RE: CUYAHOGA COUNTY
CITY OF BEACHWOOD
CONSTRUCTION STORM WATER
PERMIT NO: 3GC06128*AG
ALOFT HOTEL

NOTICE OF VIOLATION

Figures 1 & 2: Fence in need of repair; stakes need to be tied off together; window in catch basin needs to be covered.

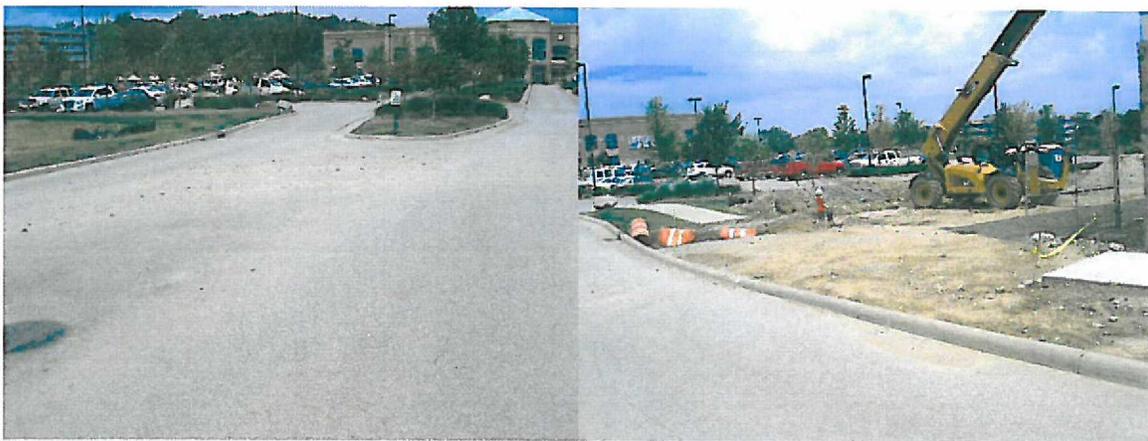
- **Silt fence has not been installed in a functional manner and has not been maintained as required by the NPDES Permit.** Silt fence must be trenched and backfilled and the joint stakes of the silt fence must be connected by twisting the stakes together prior to staking them into the ground. Silt fence on the eastern side of the site was not twisted at the stakes and parts had been trampled down by sediment (Figure 1). Please ensure that all joints are twisted together and repair silt fence so that it is functional. Silt fence must remain in place until the upslope contributing drainage area has reached final stabilization, i.e., a vegetative growth density of 70% or greater has been achieved. **Failure to install silt fence in a functional manner is a violation of Part III.G.2.d of the NPDES permit and Ohio Revised Code (ORC) 6111.04 and 6111.07. Failure to maintain silt fence is a violation of Part III.G.2.h of the NPDES permit and ORC 6111.04 and 6111.07.**

- **Storm drain inlet protection on the northeastern side of the site is insufficient.** There is an exposed window on the side of the casting (Figure 2). Straw bales have been placed in front of the window, but this is not an accepted form of inlet protection. As long as the drainage area to the eastern ditch remains disturbed, inlet protection is required. Please review the specifications in *Rainwater and Land Development, Ohio's Standards for Stormwater Management, Land Development and Urban Stream Protection* (Ohio Department of Natural Resources, 2006), repair inlet protection to meet these standards. **Failure to install storm drain inlet protection in a functional manner is a violation of Part III.G.2.d of the NPDES permit and ORC 6111.04 and 6111.07.**
